Technical Service Bulletin: tsb100362

Released Date: 03-May-2005

Fuel Line Bracket

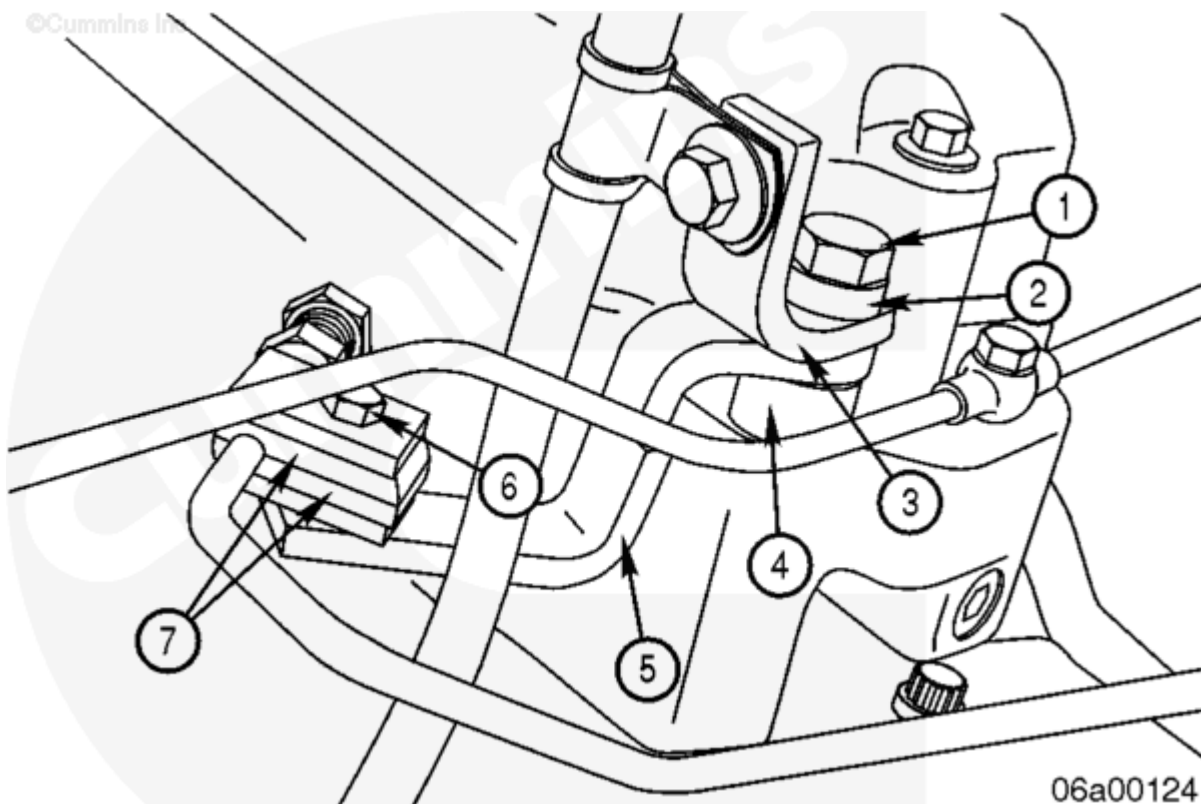
This Technical Service Bulletin announces an additional bracket to be placed on the right bank cylinder number 3 fuel line. Due to a large unbracketed span of the fuel line, the fuel line was able to vibrate and some have cracked due to high cycle fatigue.

The bracket components used have the same part numbers used on other fuel lines. No new components were needed or released. The parts will be added in production and are available to order for upfit.

3094813	Capscrew, hexagon head flange (from rocker lever box location). This screw is replaced with part number 3093764.	1
---------	--	---

The Engine Serial Number (ESN) first for the additional bracket being installed in production is 37216997. The first build date was April 11, 2005.
